Subject: Duke Energy Carolinas, LLC  
William States Lee III Nuclear Station – Docket Nos. 52-018 and 52-019  
AP1000 Combined License Application for the  
William States Lee III Nuclear Station Units 1 and 2  
Supplemental Response to Request for Additional Information  
Ltr# WLG2012.04-08

**Lee Nuclear Station Response to Request for Additional Information (RAI)**

**Reference NRC RAI Number: ER RAI 190 Supplement, Site Layout and Plant Description**

**Reference NRC RAI Number: ER RAI 210 Supplement, Ecology - Aquatic**

Updated ER Figure 5.3-2,  
Make-Up Pond B Intake Structure  
Sheets 1 through 7 of 7

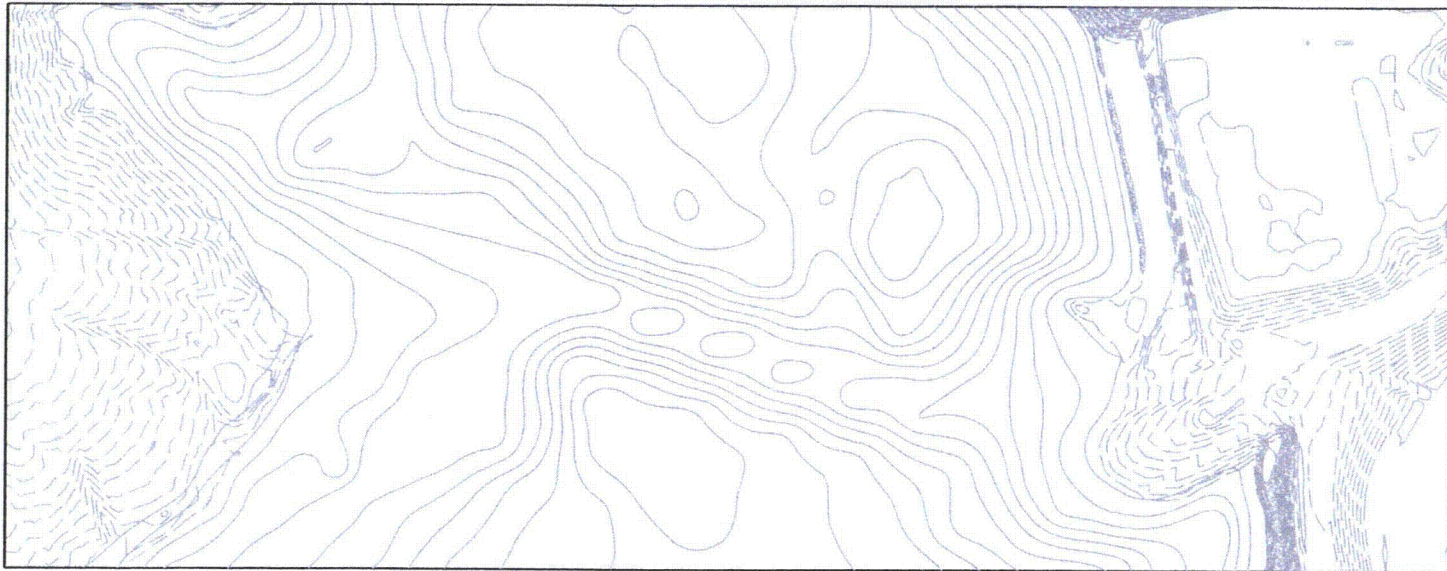
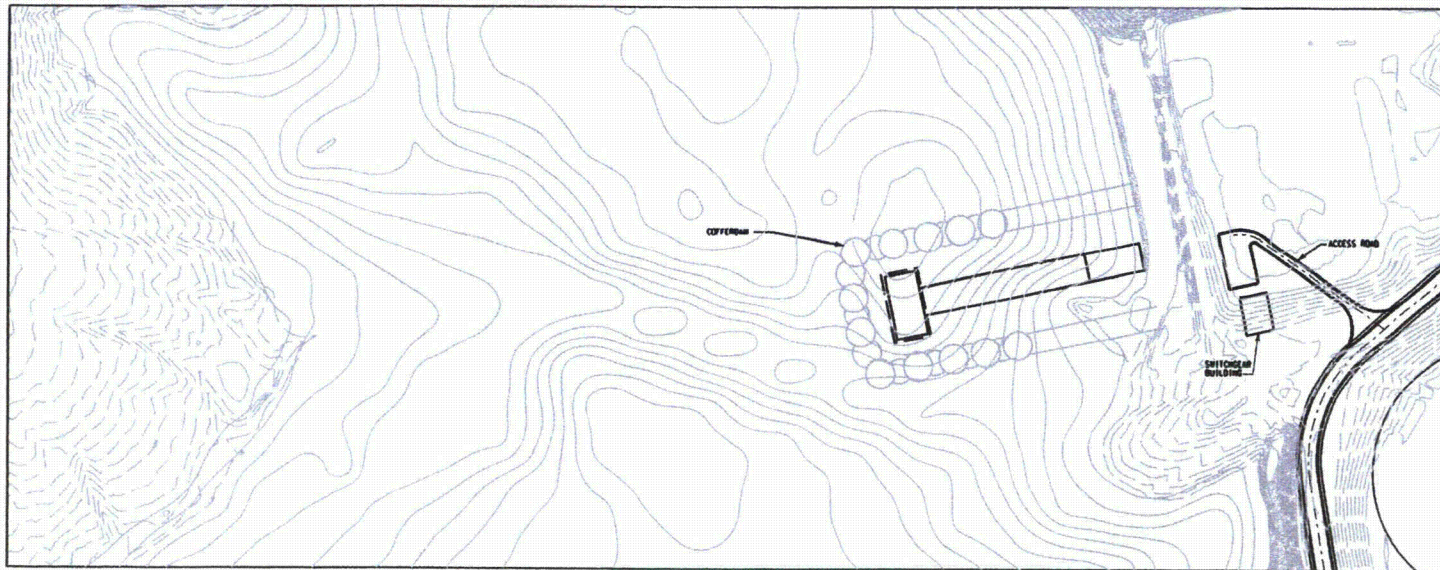
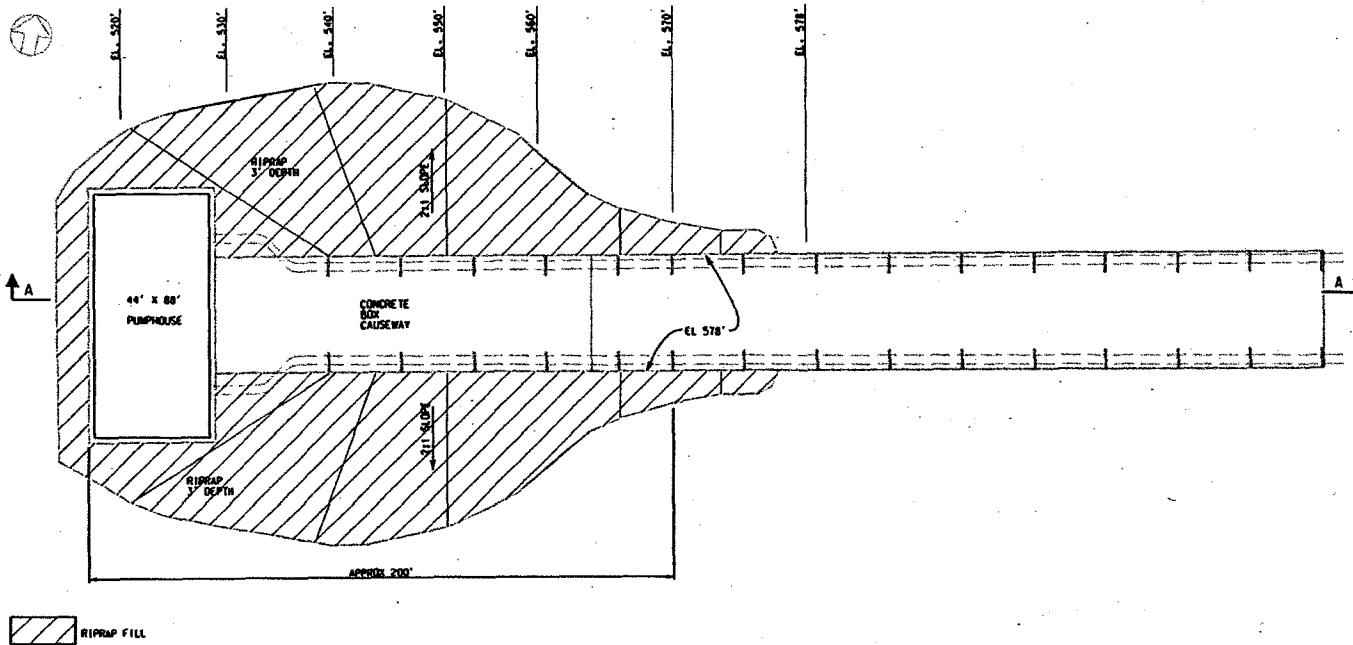
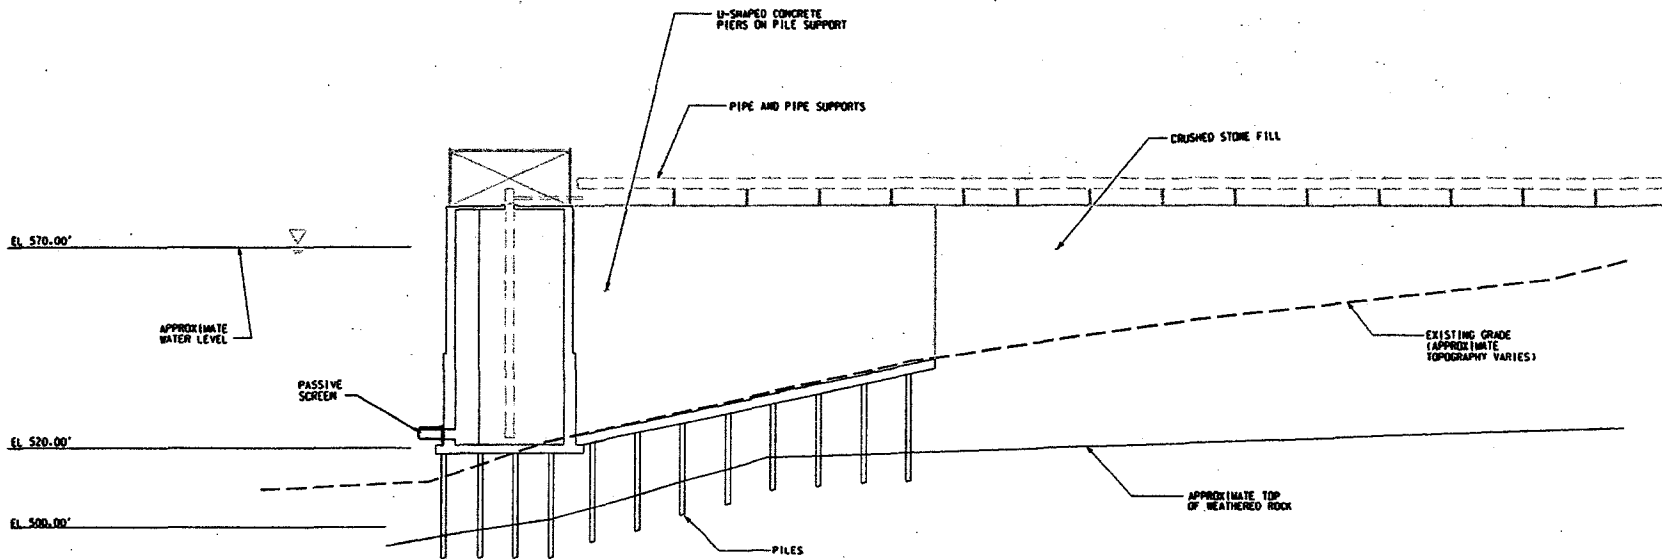
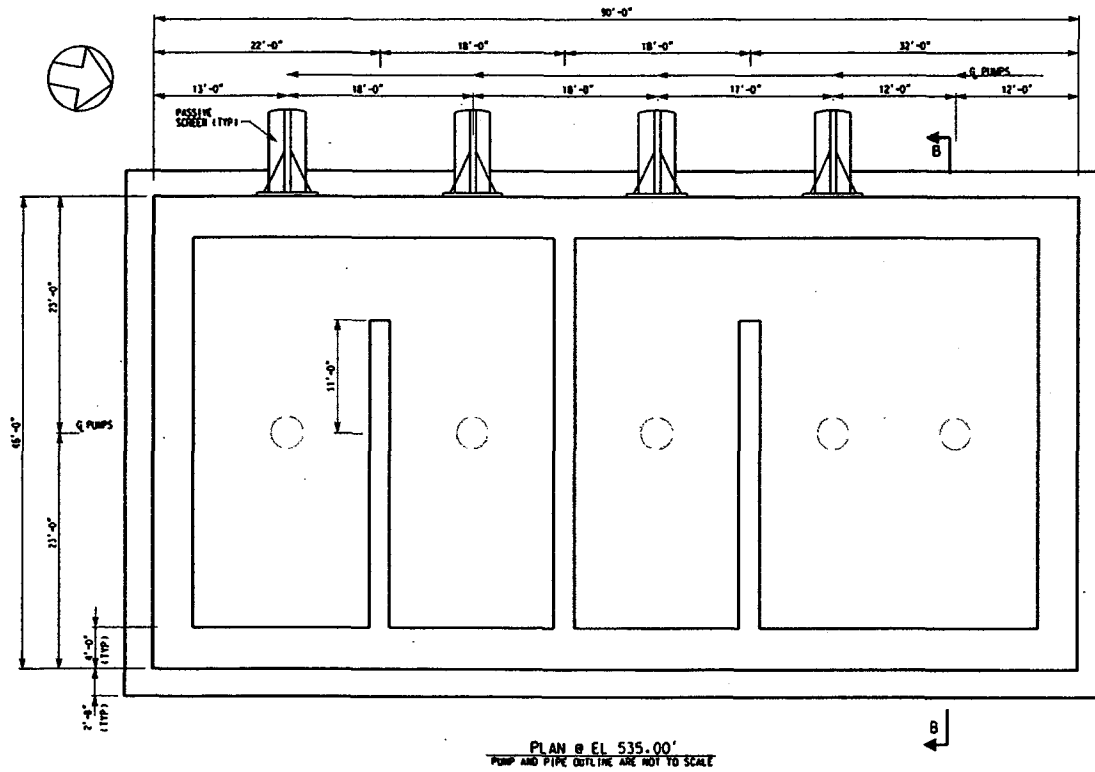
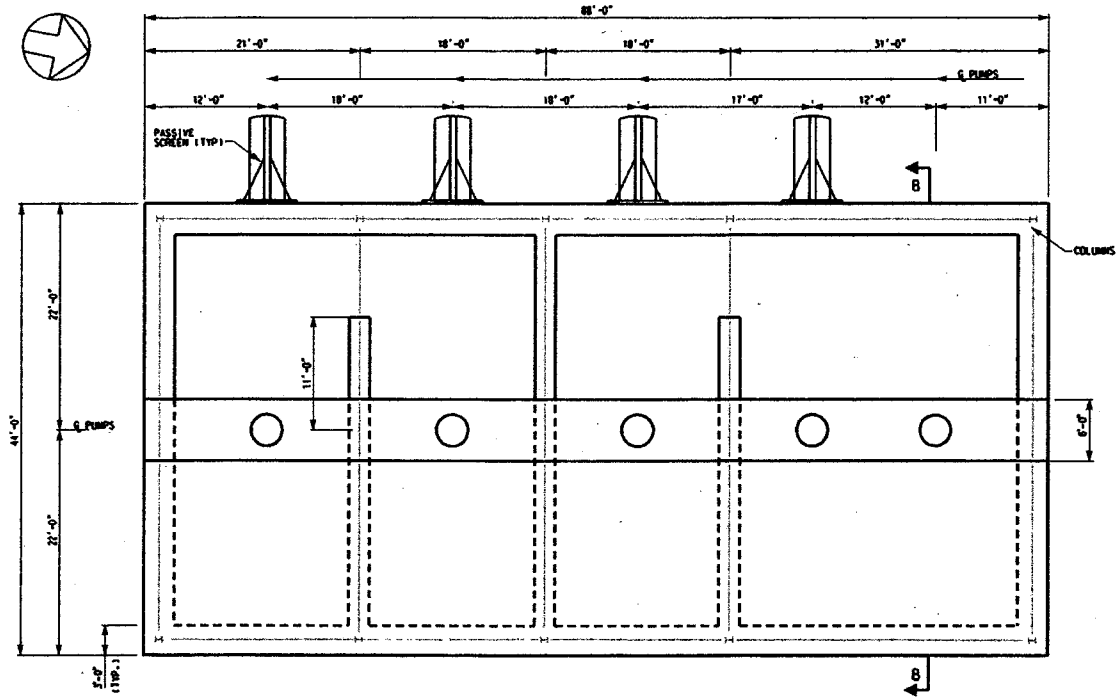
Provide bathymetric maps of Ponds A, B, and C that show clearly labeled contour lines with the locations of the intake screen and supporting structures superimposed. Provide plan and section views of each intake structure. For clarity and legibility, print the maps in black and white. Describe what is known about the options for wedge wire slot sizes for the traveling screens, particularly if an estimate or range of potential slot sizes is known. Provide information about the height the Pond B and C drum screens will be elevated above the substrate. Also, describe the potential cleaning methods for the Ponds A, B, and C intake screens. Indicate in the response when and how through-screen velocity calculations will be provided to the NRC (e.g., through submittal of a copy of the National Pollution Discharge Elimination System permit application).

The plan and section views of the Make-Up Pond B and Make-Up Pond C Intake Structures have each been shown on a separate sheet to enhance legibility of the intake structure drawings, ER Figures 5.3-2 and 5.3-5 respectively (Attachments 210S-02 and 210S-03). Additional details of the Passive Wedge Wire Cylindrical Drum Screens have been added to the plan and section views of the Make-Up Pond B Intake Structure as reflected on ER Figure 5.3-2 (Attachment 210S-02). Likewise, additional details of the Passive Wedge Wire Cylindrical Drum Screens have been added to the plan and section views of the Make-Up Pond C Intake Structure as reflected on ER Figure 5.3-5 (Attachment 210S-03).
